# service bulletin

NUMBER: 80-1 DATE: 10/24/79

### REQUIRED Fuel System Rework on the Following 1979 Merc 4.5 Motors ONLY.

1979 MERC 4.5

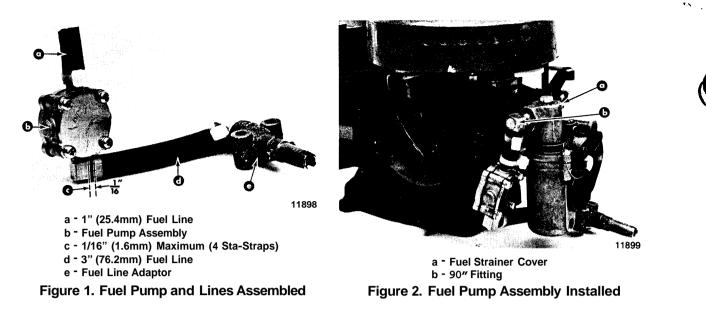
Mercury Marine has determined that the fuel line routing on some 1979Merc 4.5 motors (serial numbers specified above) must be reworked to reduce the possibility of a fuel leak and prevent a potential fire hazard.

**NOTE:** The Kit consists primarily of a newfuel pump assembly (with a 90" inletfitting), a new carburetor strainer cover (with a 90" inlet hole) and twofuel lines - required to properly align the fuel line routing and assure that the fuel line connections are secure.

- 1. Apply a small amount of Perfect Seal (C-92-34227) or equivalent pipe thread sealant to threads of 90° fitting (removed from old strainer cover) and install fitting into new strainer cover (supplied). (Figure 2)
- 2. Assemble new fuel pump, strainer cover, fuel line adaptor and fuel lines, as shown in Figures 1 and 2.

IMPORTANT: "Arrows" on fuel pump indicate direction of fuel flow to carburetor. New sta-straps (supplied in kit) MUST BE USED. Make certain that fuel lines are installed <u>all</u> the way on the fittings and position sta-straps 1/16" (1.6mm) MAXIMUM from ends of fuel lines (pull sta-straps tight with a pliers).
